## Discretionary Review Abbreviated Analysis

*Date:* August 7, 2017  
*Case No.:* **2015-018225DRP**  
*Project Address:* **171 JUDSON AVENUE**  
*Permit Application:* 2015.11.09.2182  
*Zoning:* RH-1 [Residential House, Single Family]  
40-X Height and Bulk District  
*Block/Lot:* 3182/032  
*Project Sponsor:* Suheil Shatara  
26 Lakeview Drive  
Daly City, CA 94015  
*Staff Contact:* Sylvia Jimenez – (415) 575-9187  
[Sylvia.Jimenez@sfgov.org](mailto:Sylvia.Jimenez@sfgov.org)  
*Recommendation:* **Do not take DR and approve as proposed**

Discretionary Review Hearing  
Case Number 2015-018225DRP  
171 Judson Avenue

Vertical Expansion

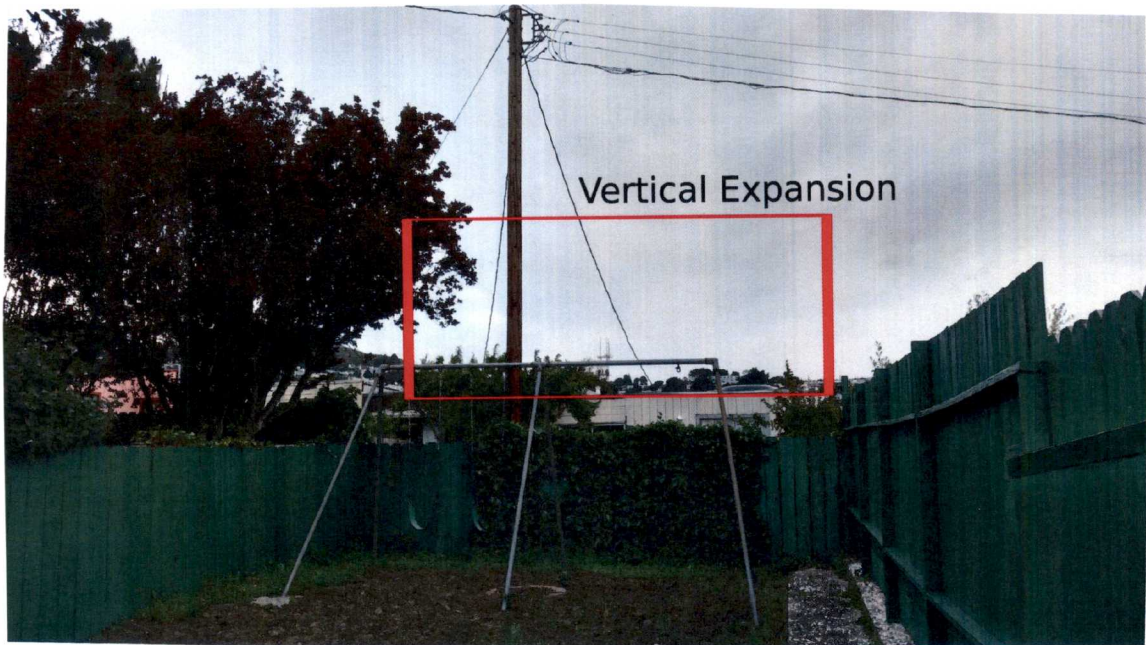
We believe the proposed vertical addition with rear deck and total of 7 bedrooms will drastically change the character of our neighborhood. Our block, in particular, has a visual character that is uniform in scale with no homes having a third story addition or rear deck, that I am aware of. The proposed plans will disrupt the existing pattern and be an eye sore, especially with the rear deck that will sit high above the fence line and be visible from nearly every backyard in the block where none currently exist.
